PVNGS UNIT 1

**MARKED UP TECHNICAL SPECIFICATIONS
TO SUPPORT NRC GENERIC LETTER 88-16**

FIGURE 3.2-1A
AZIMUTHAL POWER TILT LIMIT vs. THERMAL POWER
(COLSS IN SERVICE)

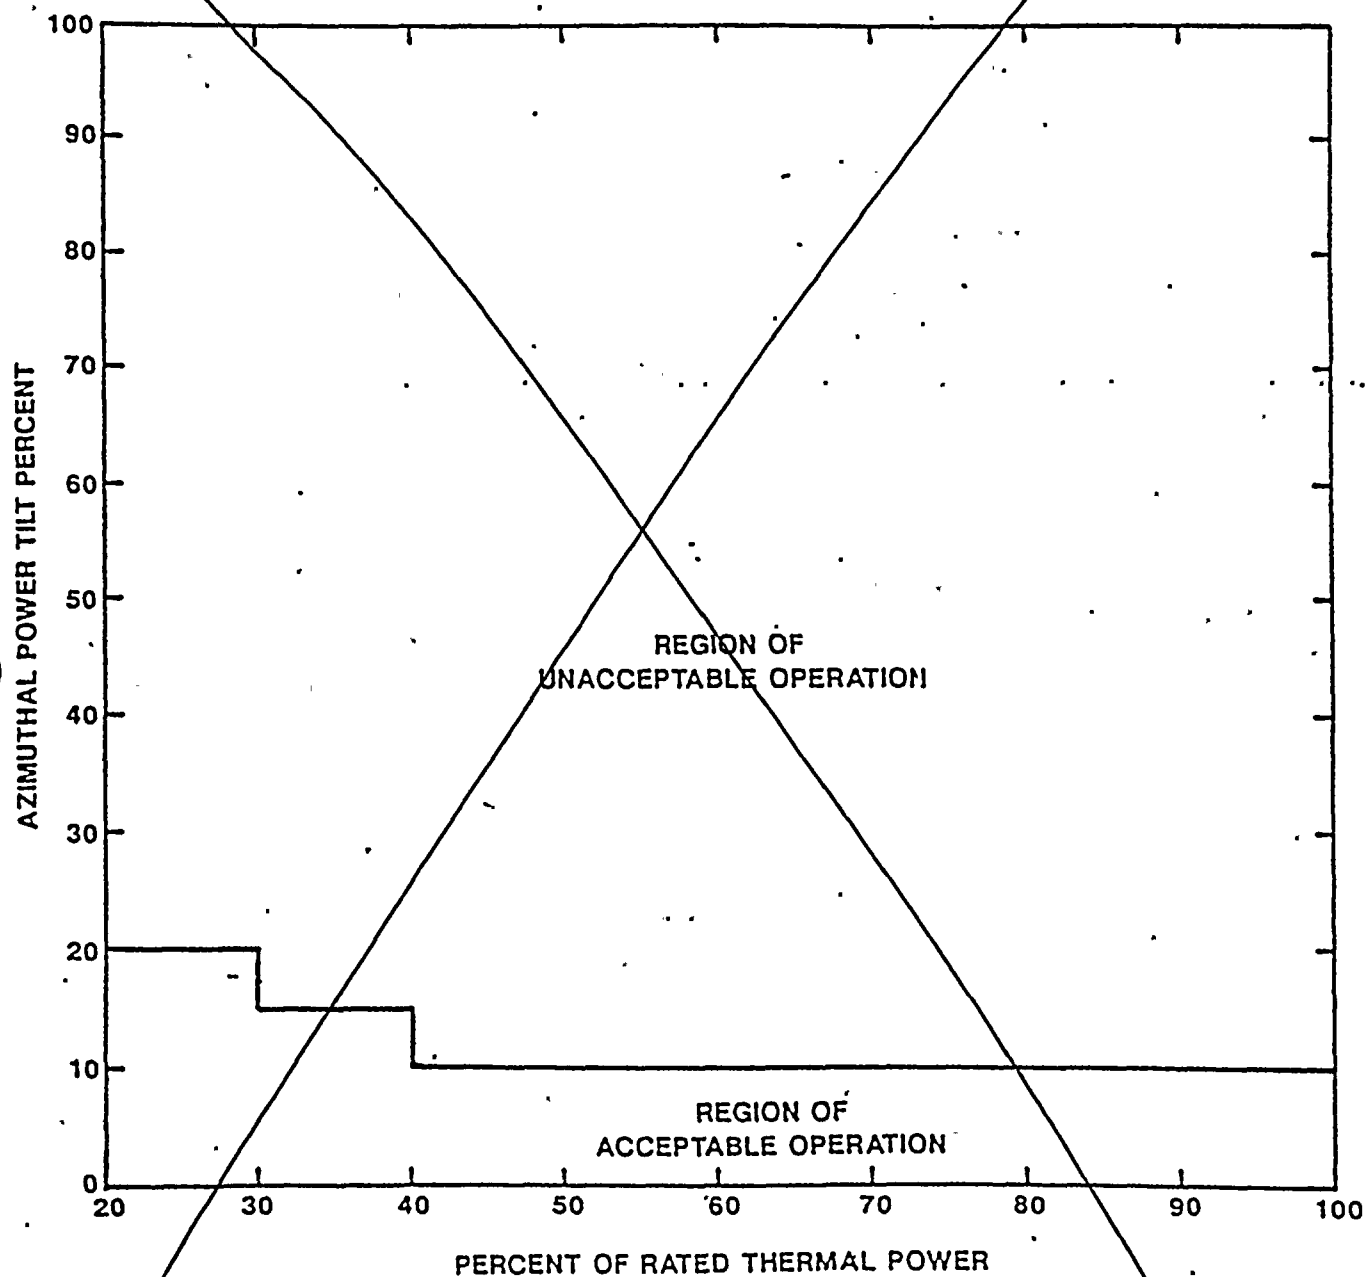
- a. The AZIMUTHAL POWER TILT Allowance used in the Core Protection Calculators (CPCs), and specified in the CORE OPERATING LIMITS REPORT
- b.1. The limit ~~in Figure 3.2-1A~~ with COLSS in service, or
- b.2. $T_q \leq 0.10$ with COLSS out of service.

- b. With the measured AZIMUTHAL POWER TILT determined to exceed the limit ~~in Figure 3.2-1A~~ with COLSS in service or 0.10 with COLSS out of service:

DELETE
PAGE

FIGURE 3.1-1A
SHUTDOWN MARGIN vs. COLD LEG TEMPERATURE

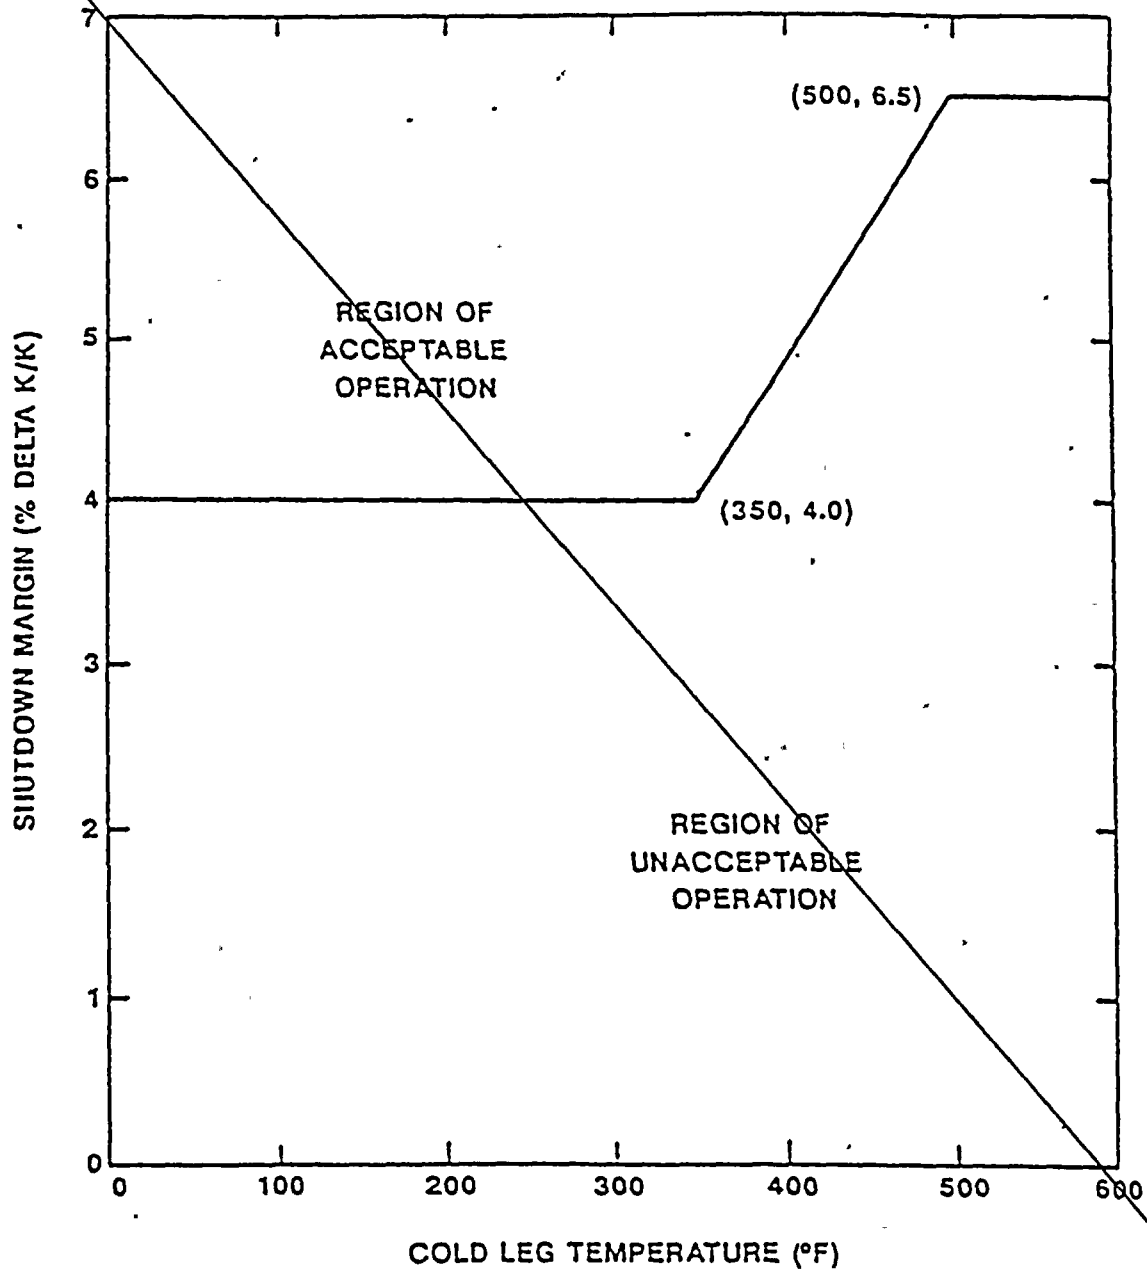
a. The SHUTDOWN MARGIN shall be greater than or equal to that shown in ~~Figure 3.1.1A~~, and

a. With the SHUTDOWN MARGIN less than that ~~in Figure 3.1.1A~~, immediately initiate and continue boration at greater than or equal to 26 gpm to the reactor coolant system of a solution containing greater than or equal to 4000 ppm boron or equivalent until the required SHUTDOWN MARGIN is restored, and

DELETE

FIG. 3.1-1

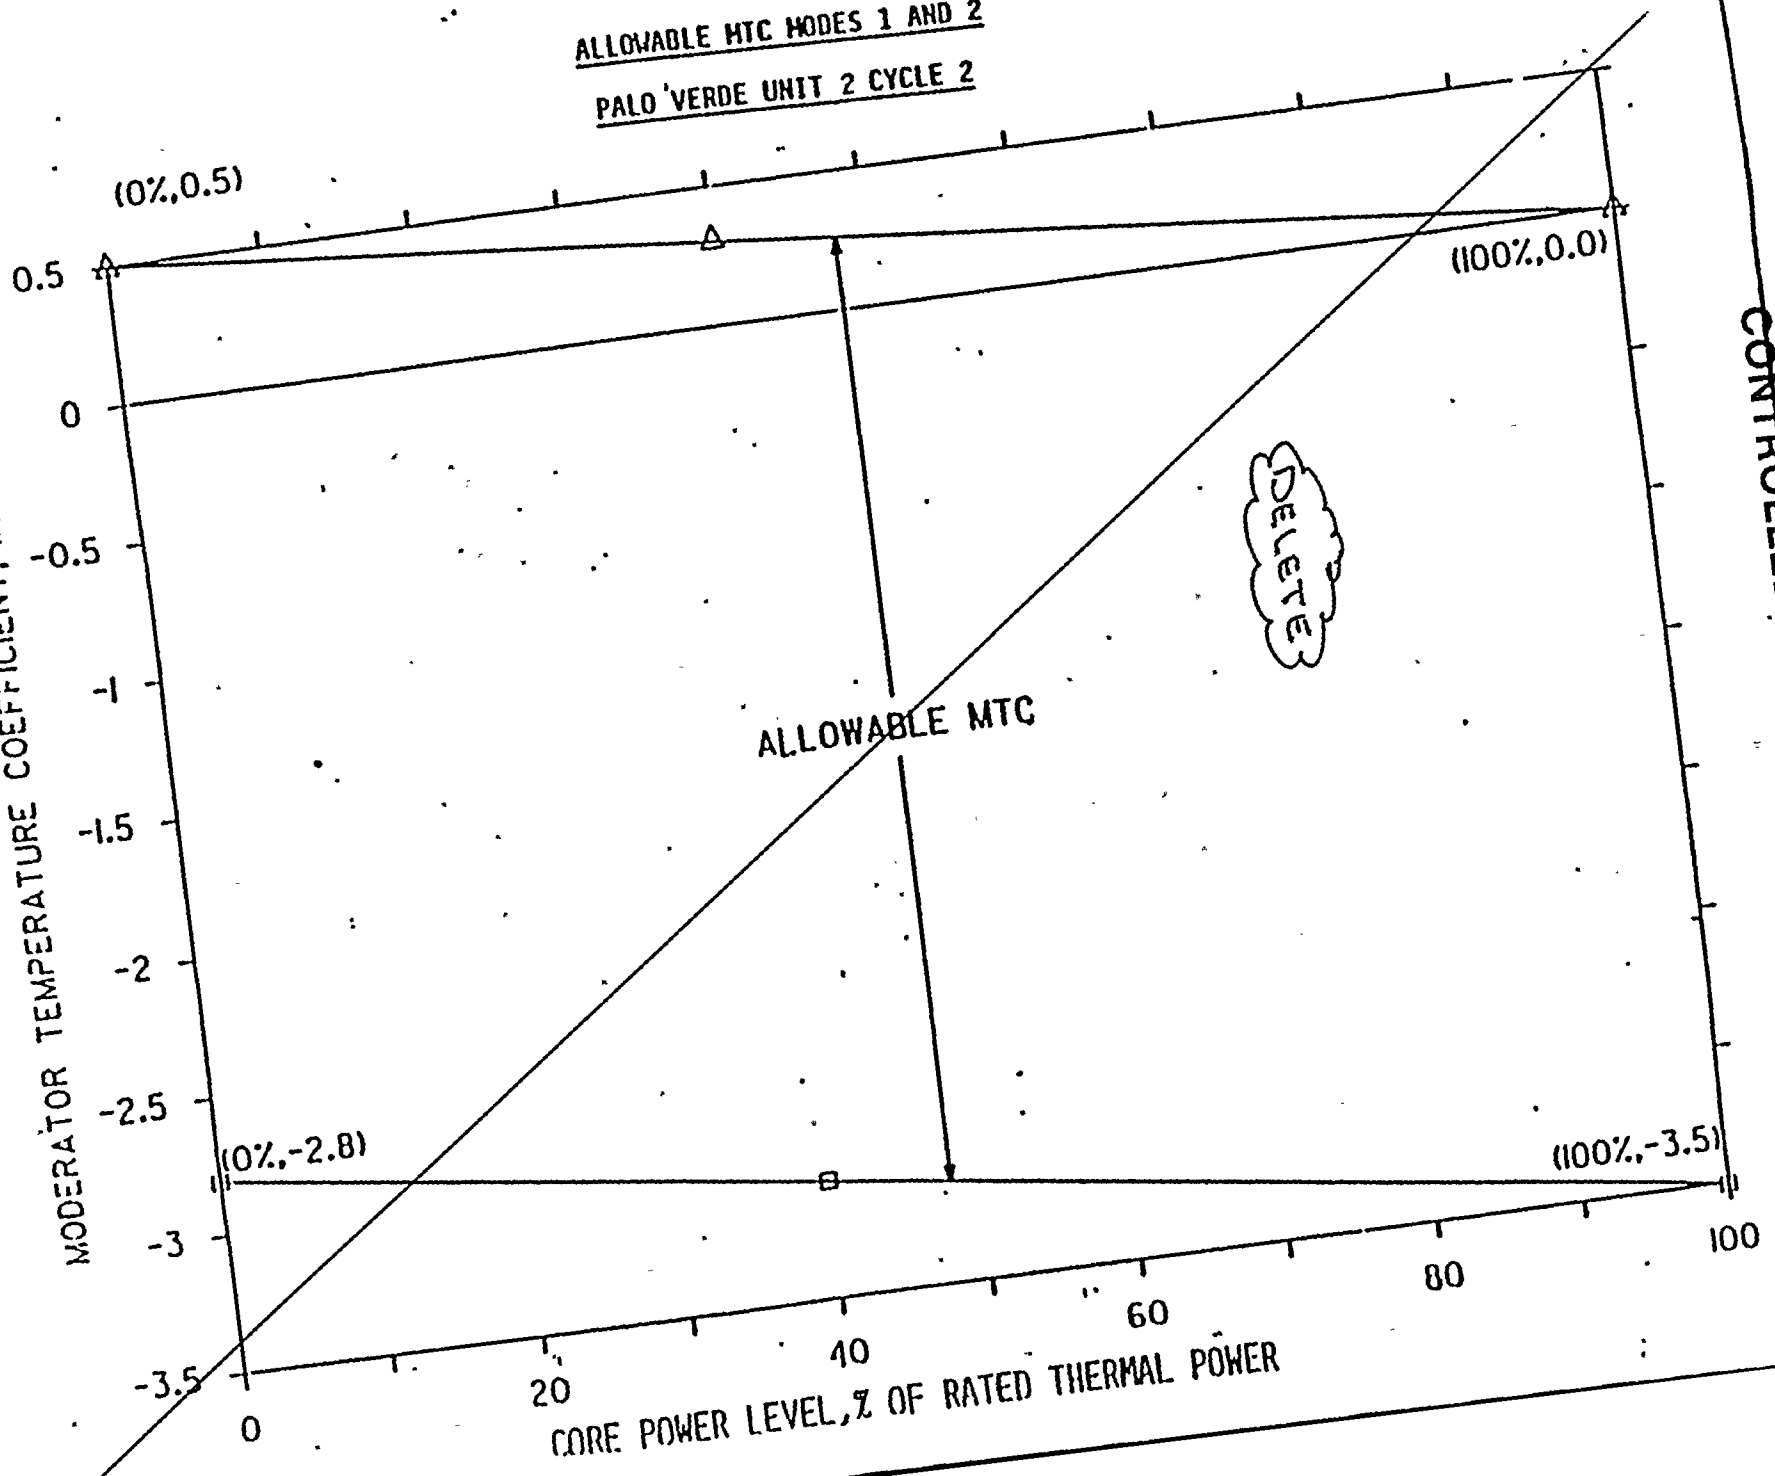
3.1.1.3 The moderator temperature coefficient (MTC) shall be within the area of Acceptable Operation ~~shown on Figure 3.1.1.~~

With the moderator temperature coefficient outside the area of Acceptable Operation ~~shown on Figure 3.1.1,~~ be in at least HOT STANDBY within 6 hours.

FIGURE 3.2 - 1A
AZIMUTHAL POWER TILT LIMIT
VS
THERMAL POWER
(COLSS IN SERVICE)

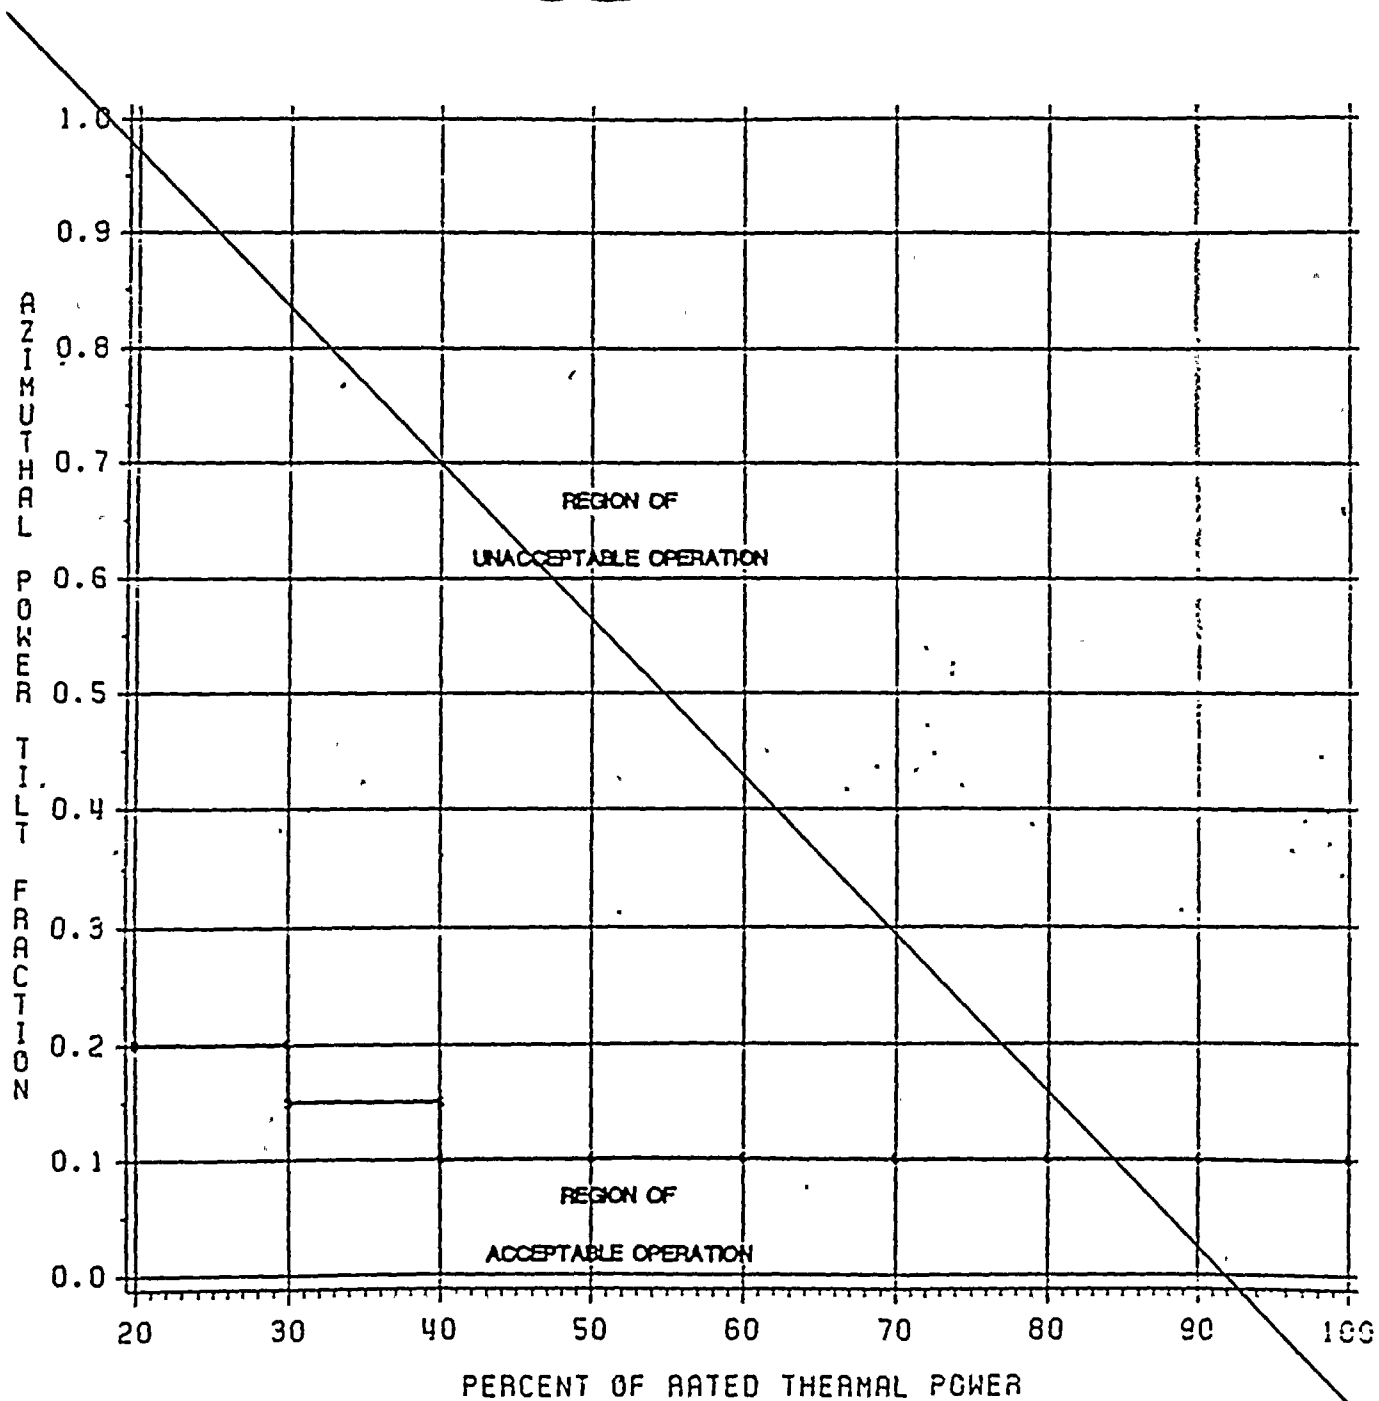
- b.1. The limit ~~in Figure 3.2-1A~~ with COLSS in service, or

- b. With the measured AZIMUTHAL POWER TILT determined to exceed the limit ~~in Figure 3.2-1A~~ with COLSS in service or 0.10 with COLSS out of service:

DELETE
